Patentee: Kevin L. Parsons, et al.)
Patent No.: 6,749,317)
Dated: June 15, 2004)
Serial No.: 10/045,231)
Filed: November 9, 2001)
Primary Examiner: J. Ward)

REQUEST FOR CERTIFICATE OF CORRECTION

Correction to FIG. 2

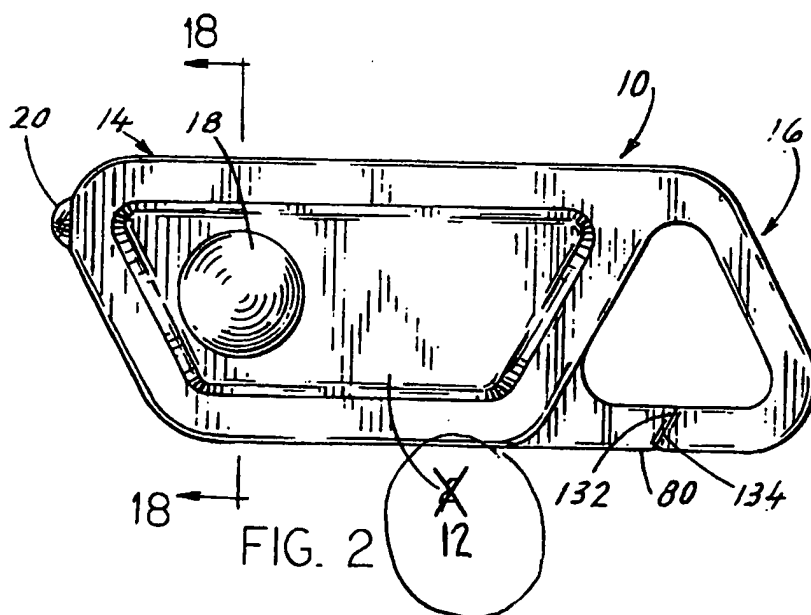
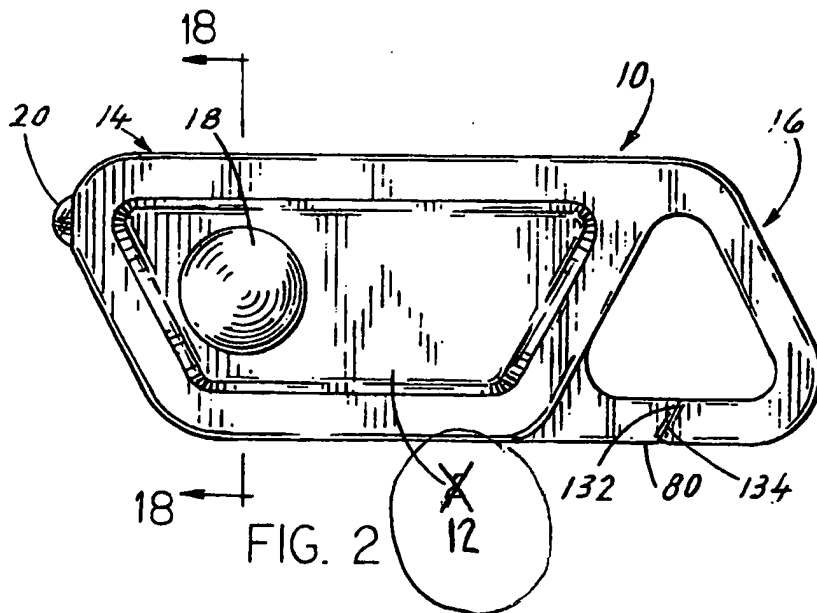
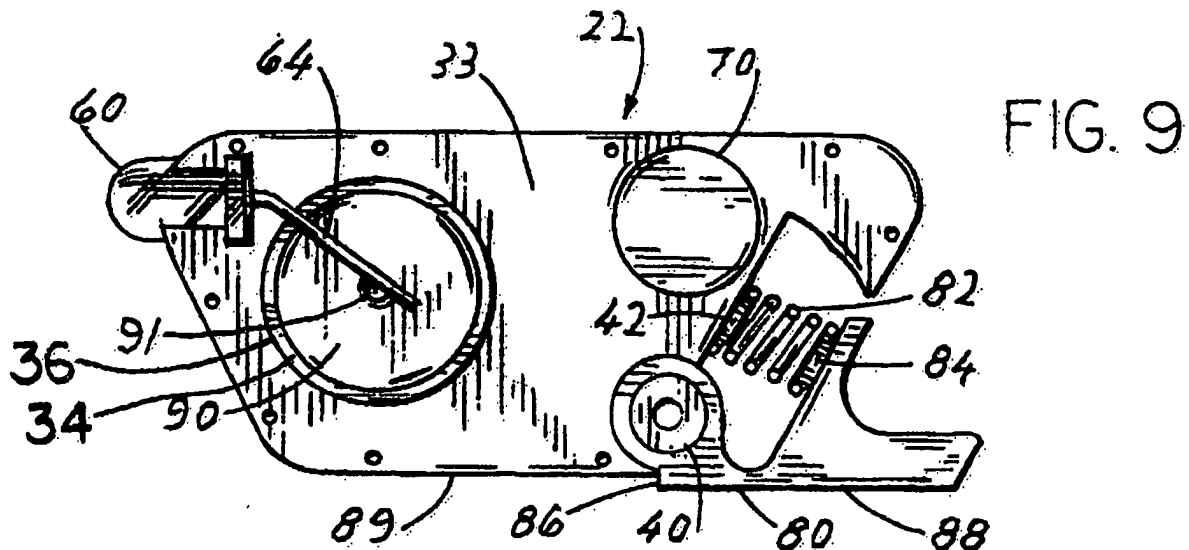
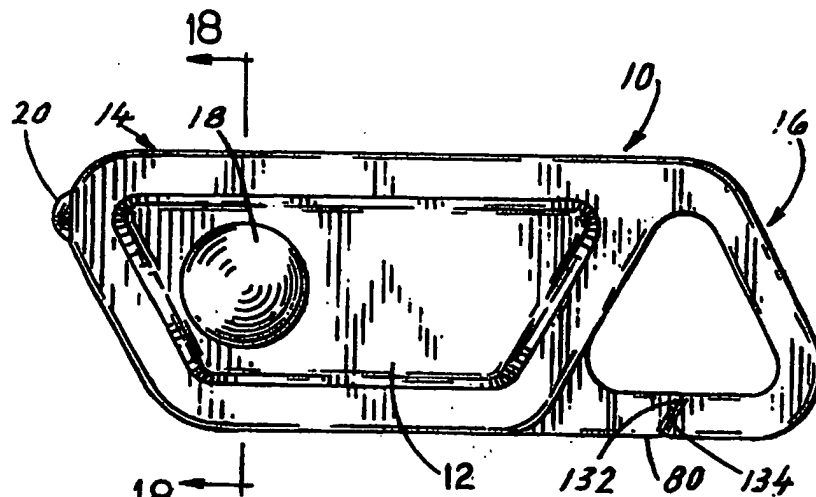
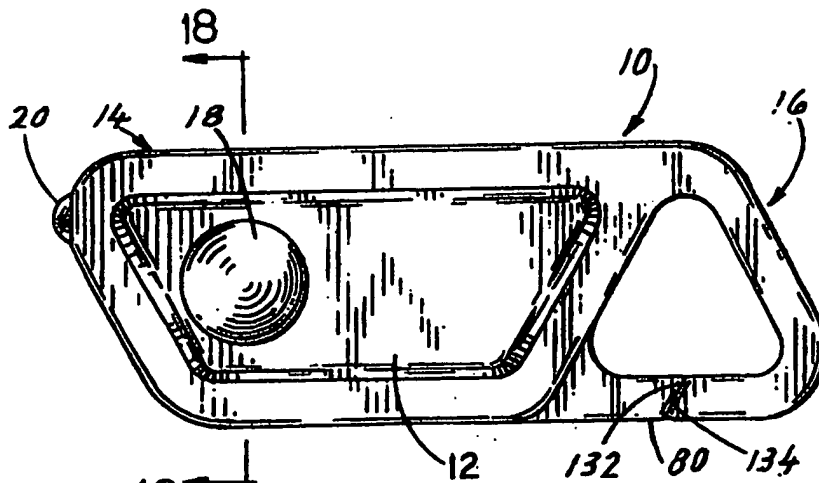
In the drawings, Sheet 1, FIG. 2, the reference numeral "2" should read --12--.

This corrects a typographical error. In the specification, reference numeral 12 refers to "a side cover" while the numeral 2 is not used. As corrected, FIG. 2 should therefore appear as follows:

Delete Figs. 2 and 9 and substitute attached Replacement Sheets for Figs. 2 and 9.

Correction to FIG. 9

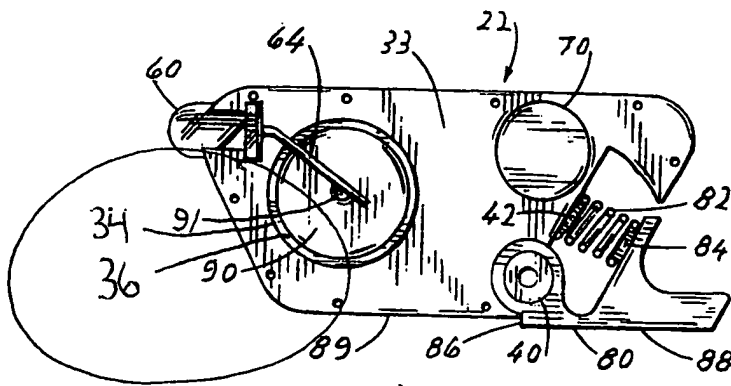
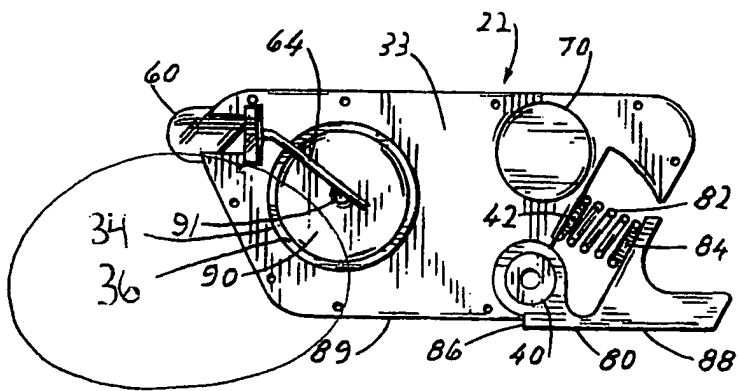
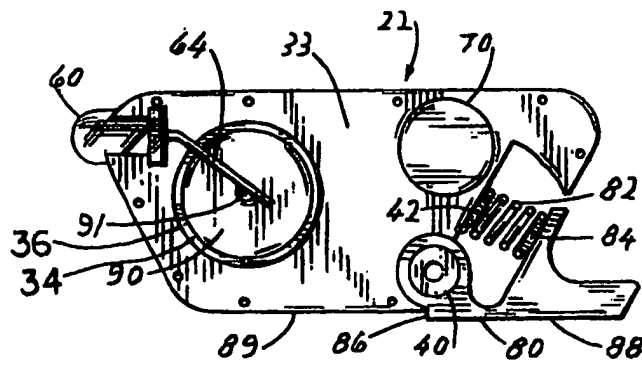
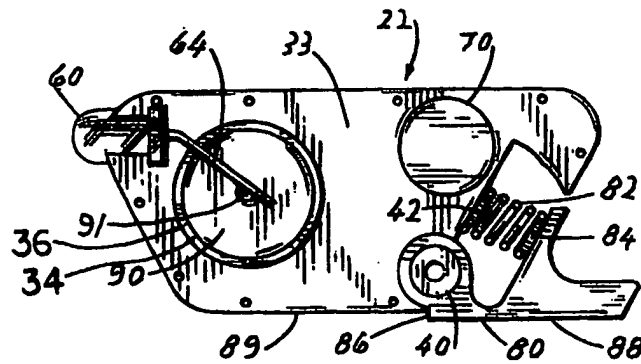
In the drawings, Sheet 3, FIG. 9, the reference numeral 34 and the related lead line should be applied to the counterbore.

In the drawings, Sheet 3, FIG. 9, the reference numeral 36 and related lead line should be applied to the terminus of the counterbore 34.

A portion of the specification that refers to FIG. 9 (see column 9, lines 1-10) identifies a counterbore 34 and a terminus 36. However, the current FIG. 9 does not have these reference numerals or lead lines for them. As corrected, FIG. 9 should therefore appear as follows:
